ADDENDUM NO. 2

February 25, 2013

RE: **Kitchen Improvements at Bancroft Elementary School**
700 North Lombard Street, Wilmington, Delaware 19801
for
Christina School District
700 North Lombard Street, Wilmington, Delaware 19801
EIA Project No. PP7279

FROM: EI Associates, Architects and Engineers
2001 North Front Street, Building 3
Harrisburg, PA 17102-2118
Telephone: (717) 233-4556 x1015 E-mail: ahollinger@eiassoc.com

DRAWING NAME:
L820 G

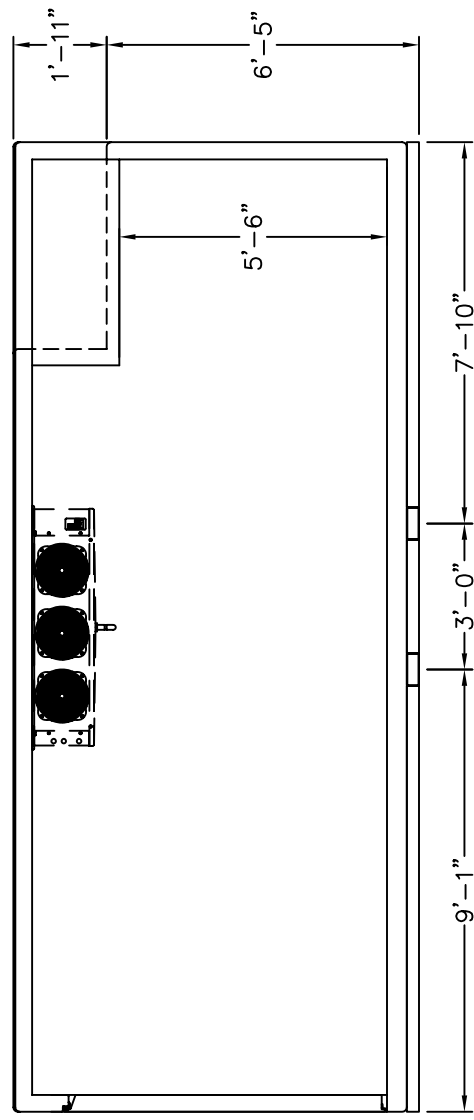
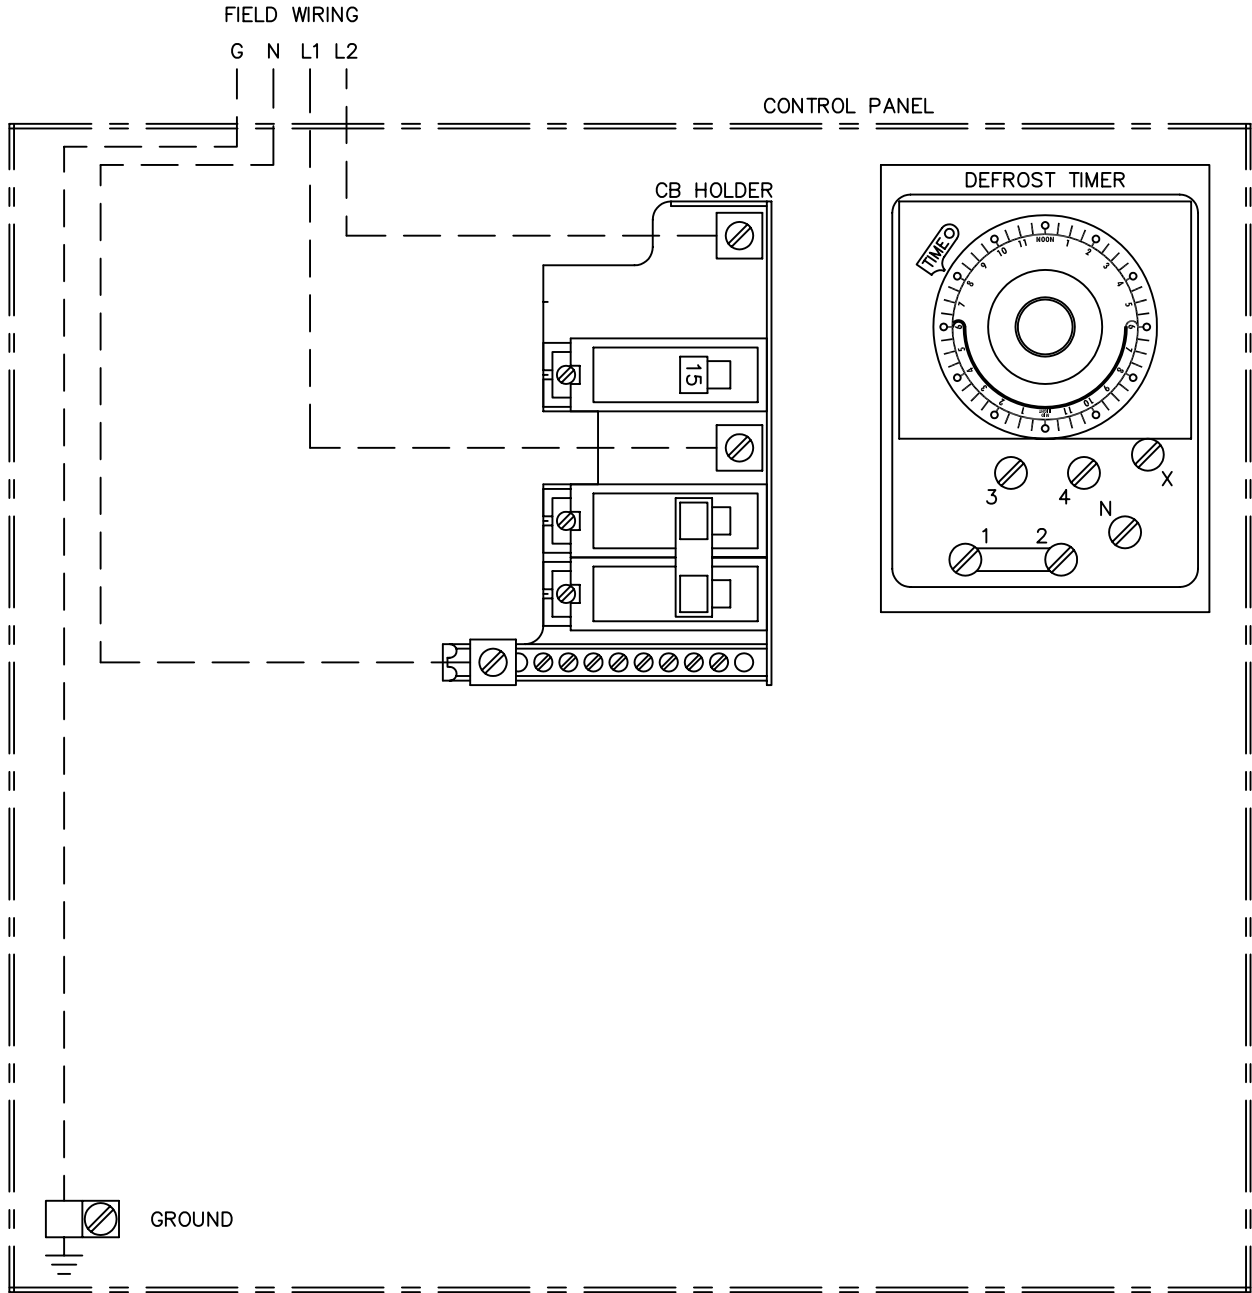
“Alternate No. 1 (Temporary Walk-In Refrigeration Unit at Sarah Pyle Academy): Provide and maintain temporary walk-in refrigeration unit for Owner’s use, starting no later than June 7, 2013 (approximate end of the current school term) and ending on August 15, 2013 or when the new Bancroft permanent walk-in units are completed and accepted by Owner, whichever is later. Locate unit at the Sarah Pyle Academy, 501 North Lombard Street, Wilmington, DE 19801. Deliver and place unit sufficiently in advance of June 7 to allow Owner time to connect power per Polar Leasing Co.’s instructions, and for Polar Leasing Co. to start up, test and demonstrate unit to Owner. Upon termination of use and disconnection of power by Owner, remove unit and restore site. Temporary unit shall conform to the following:

Model: L820 (refer also to two 8-1/2 x 11 Polar Leasing Co. drawings, copies of which accompany this addendum; which shall be attached at the end of this Section 012300)

EIA DRAWING NO.
SKFS-1

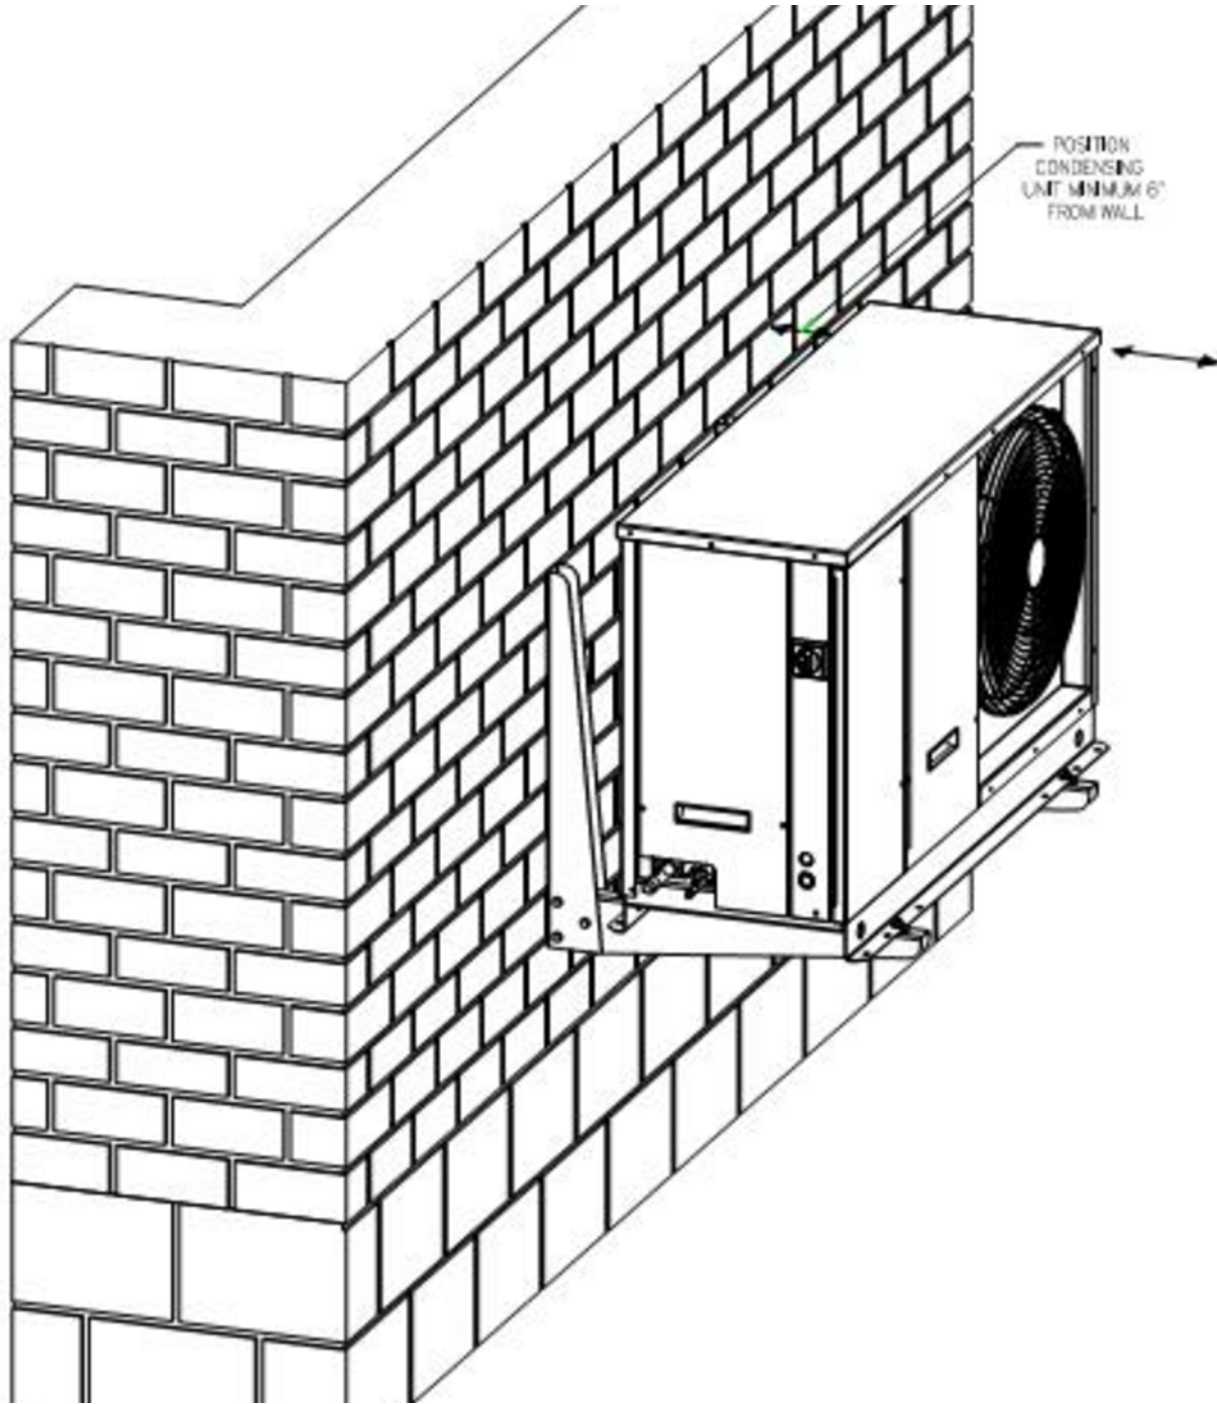
- 2.12 Drawing FS-1.7; Foodservice Equipment Utility Load Schedule: Revise electrical characteristics as shown on supplemental Drawing SKFS-1, copy of which accompanies this addendum.

EIA DRAWING NO.
ESK-1

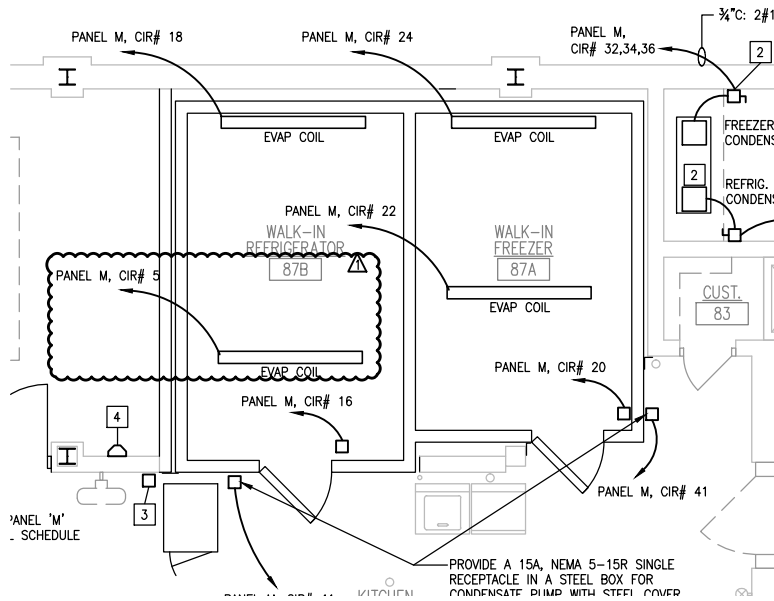
- 2.17 Drawing E1: Make the following revisions as shown on supplemental Drawing ESK-1, copy of which accompanies this addendum:
- A. Partial Floor Plan 2 – Construction: Add circuit for additional evaporator coil in walk-in refrigerator.

- B. Existing Power Panel Schedule: Add circuit and revise others.

PROJECT NO. PP7279
DRAWING NO. FS-16

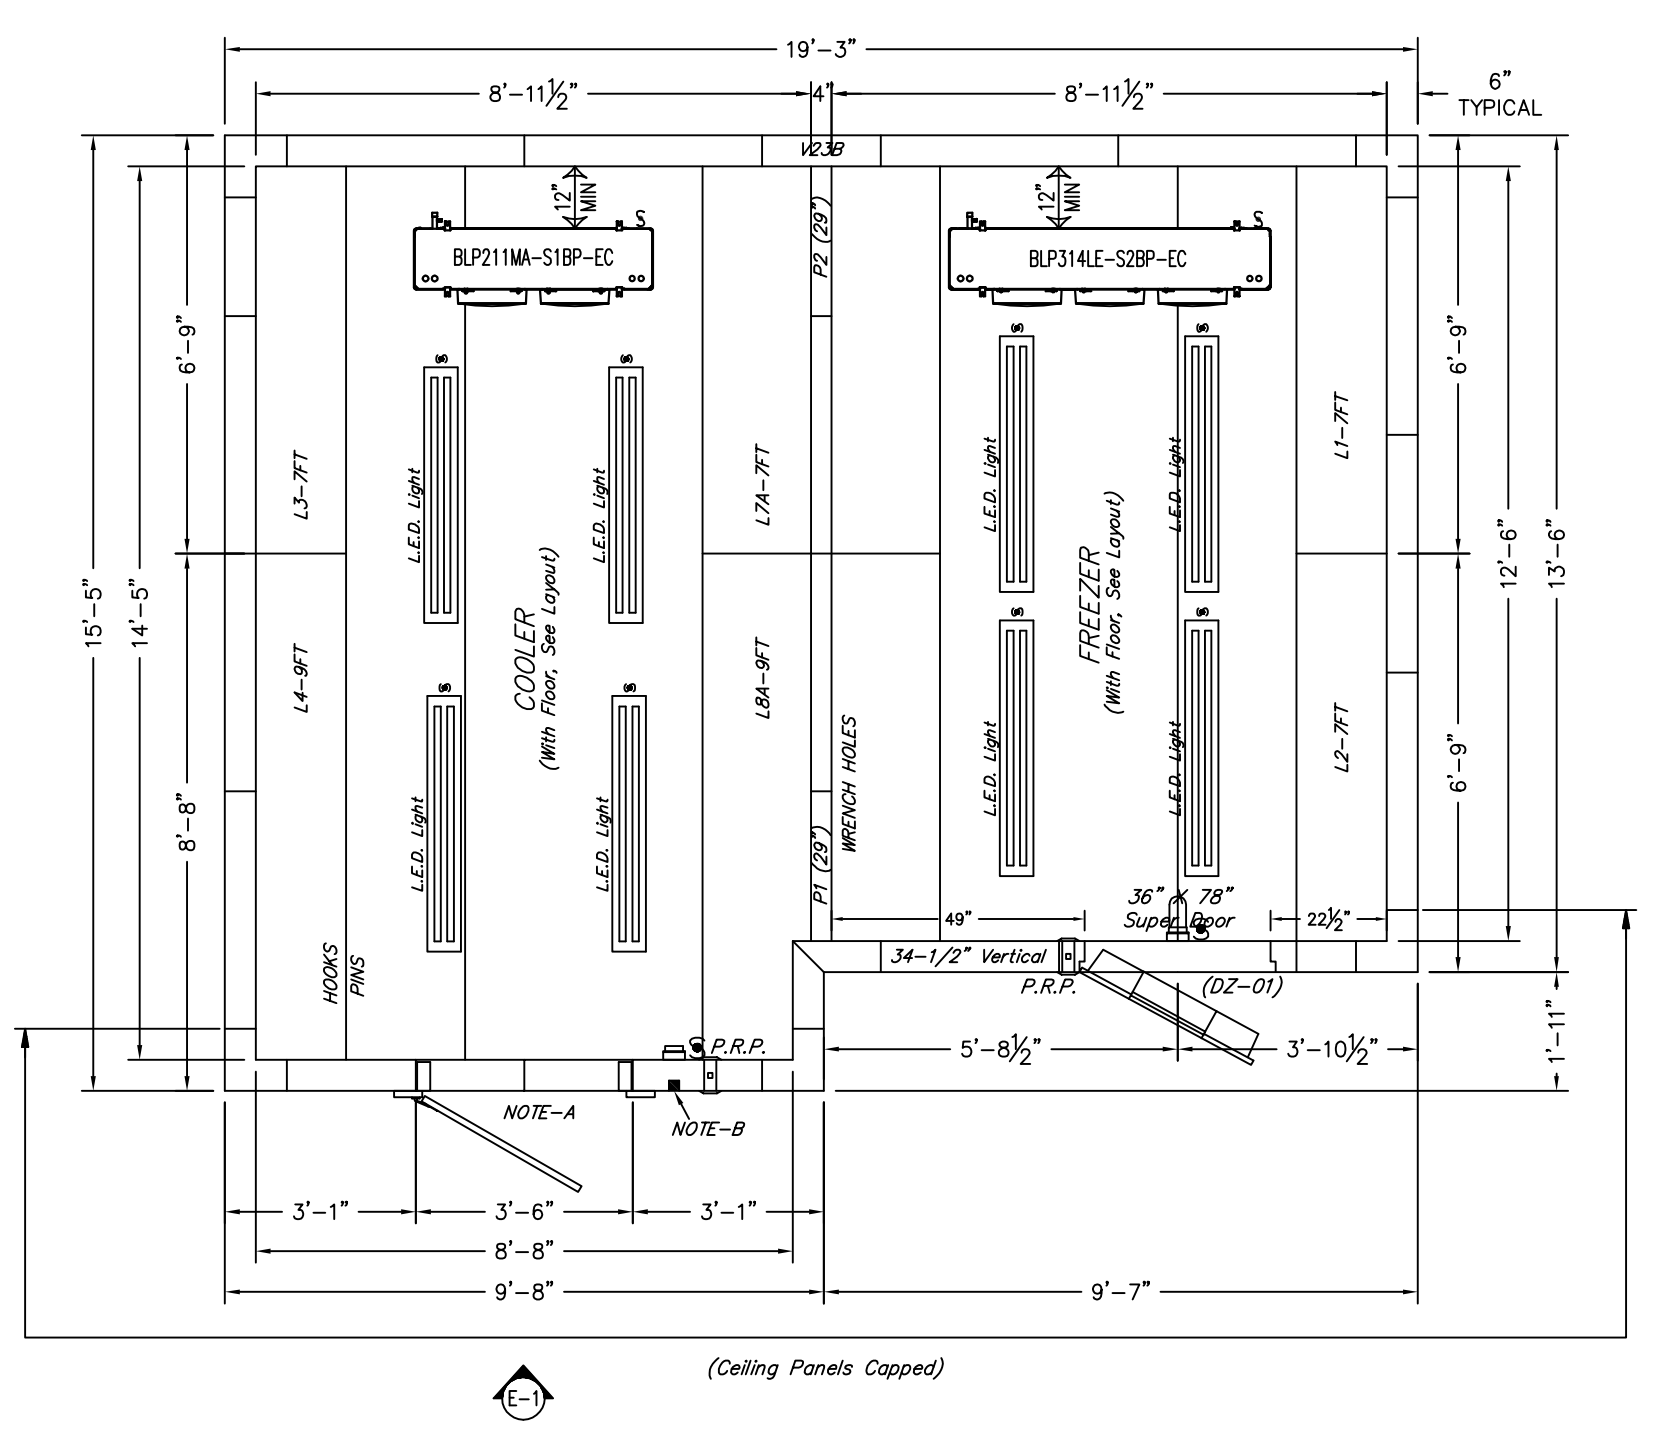
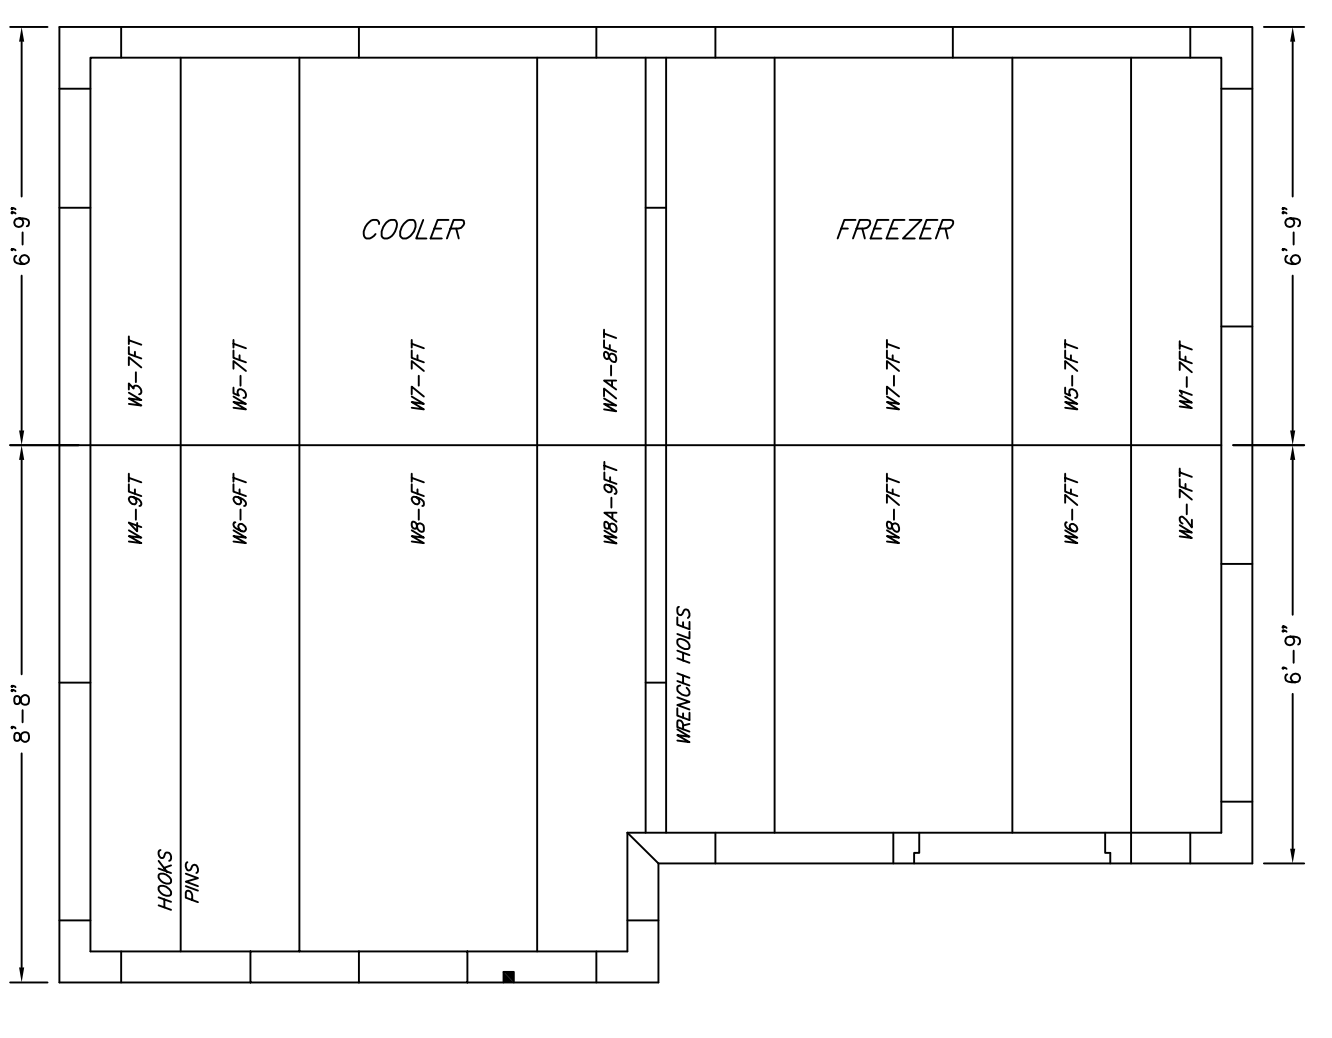
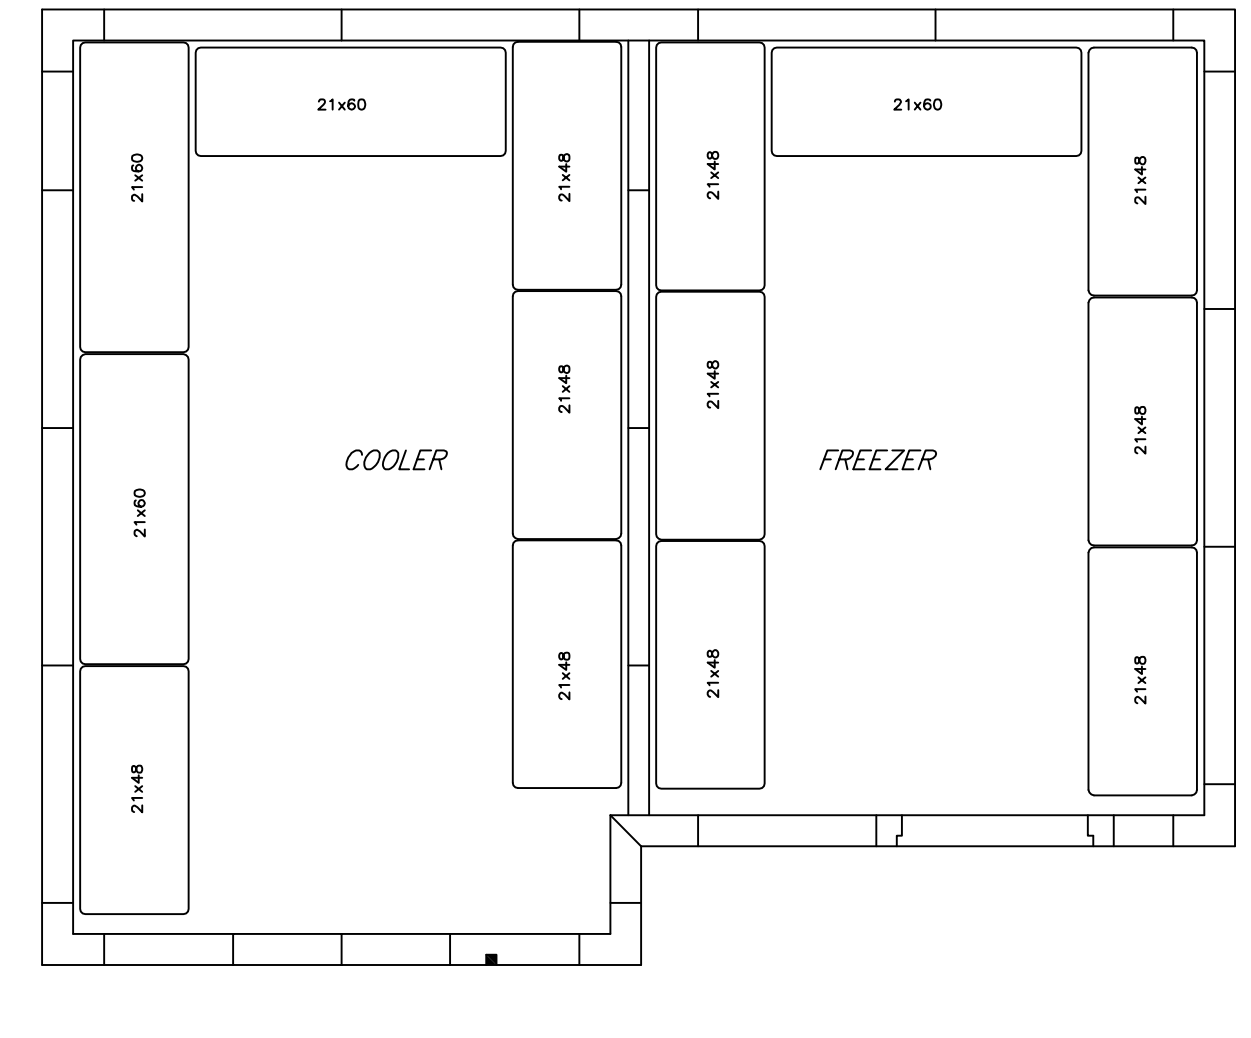
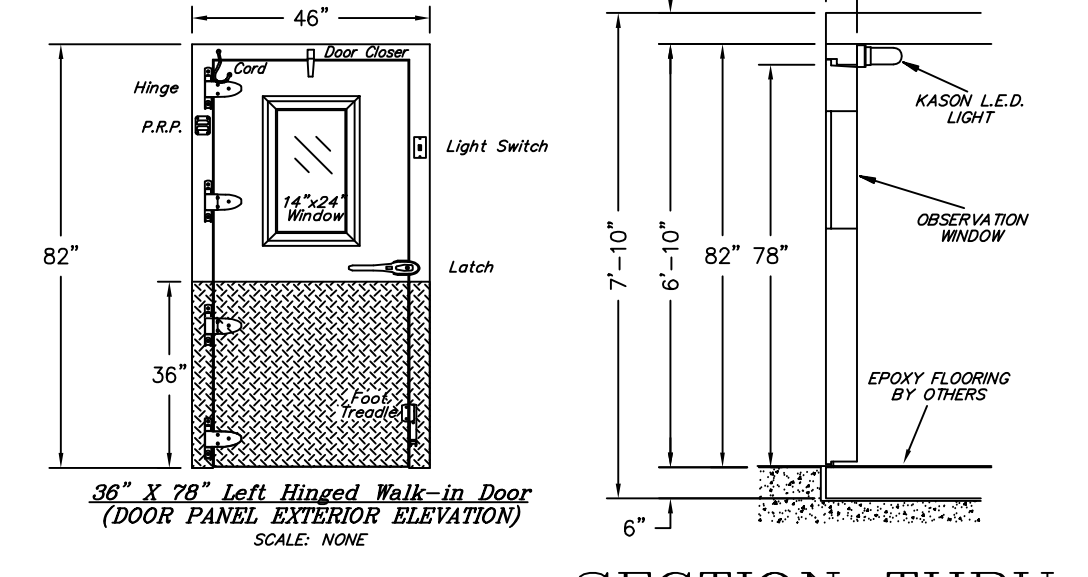
- 2.11 Drawing FS-1.6: Delete Drawing as originally included in bid set and replace with revised Drawing FS-1.6, copy of which accompanies this addendum. On the “Section Thru Entrance Door” on this new drawing, delete note referring to “Epoxy Flooring by Others.”
